ADDENDUM NO. 2 TO 11-3-2-4

FOR: Tatemville Community Center Expansion

Tatemville Community Center Expansion Addendum #2

**ADDENDUM # 2 - SD3
 TATEMVILLE COMMUNITY CENTER**

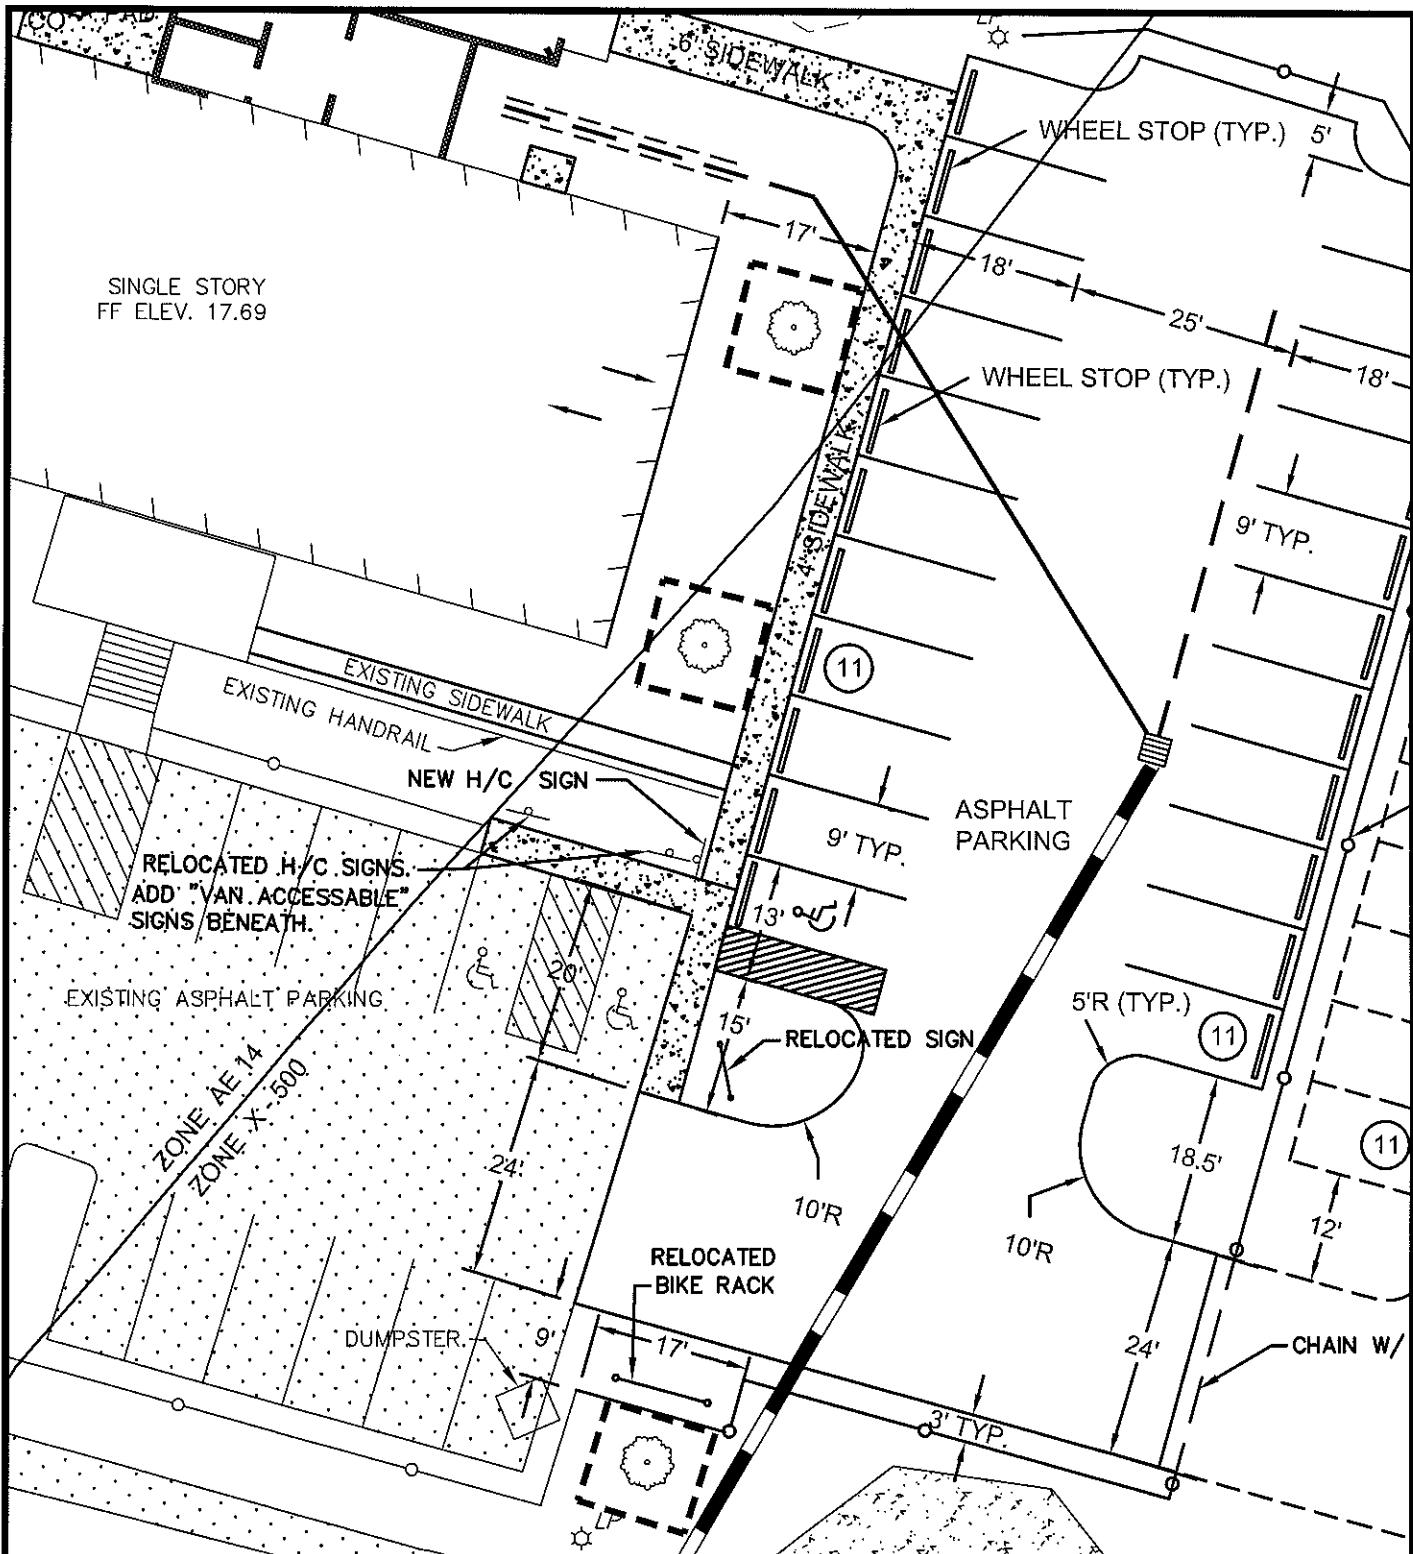
- 2.1 **Sheet C2:** Relocate two existing handicap parking signs and remove/replace wooden bollards adjacent to existing handicap parking. Remove 6 LF of existing handrail to accommodate new sidewalk.
- 2.2 **Sheet C3:** Convert one standard 9ft parking stall to a 13ft handicap space with striping and signage. This will require adding 4ft of asphalt paving to the existing parking bay. Add a 4ft wide by 24ft long section of sidewalk adjacent to and flush with the existing handicap spaces. Refer to SD3 for new configuration.
- 2.3 **Sheet C4:** Infiltration trench along the west wall of the addition shall be wrapped with impermeable liner on both sides and bottom (rather than building side only per the detail).
- 2.4 **Sheet C6:** Contractor shall install 140 LF of Type B silt fence along the edge of lake at the floodplain mitigation area.
